MIL-H-9697(USAF)
AMENDMENT 1
30 September 1958

MILITARY SPECIFICATION

HEADSET-MICROPHONE H-163( )/U

This amendment forms a part of Military Specification
MIL-H-9697(USAF) dated 6 August 1958

FIGURE 6. WIRING OF HEADSET-MICROPHONE

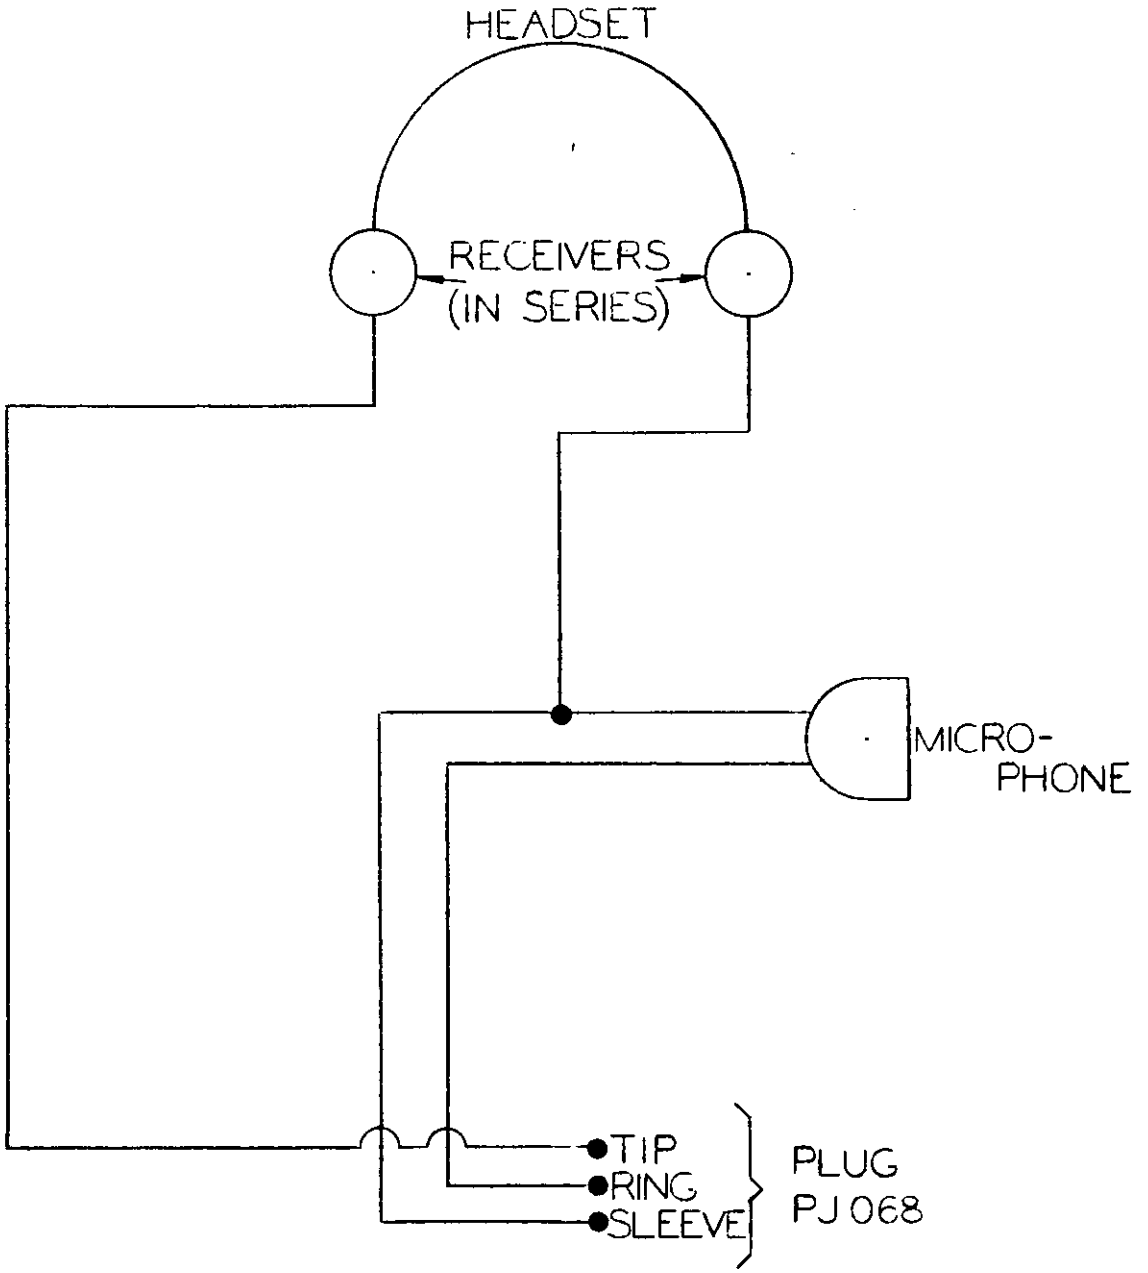
Page 9, paragraph 3.6.4, line 4: Delete "follows" and substitute "shown in figure 6".
Page 9, paragraph 3.6.4: Delete subparagraphs "a", "b" and "c" in their entirety.
Page 10, paragraph 4.4.2.2: Delete in its entirety.
Page 12, paragraph 4.4.5, subparagraph "a", line 5: After "element" add "or".
Page 12, paragraph 4.4.5 subparagraph "d": Delete in its entirety and substitute the following: "d". Over-voltage: After applying 10 volts at 400 cps directly across the receiver element terminals for 10 hours, the response shall be as specified in 3.5.1.4".
Page 18: Add the following new paragraph:
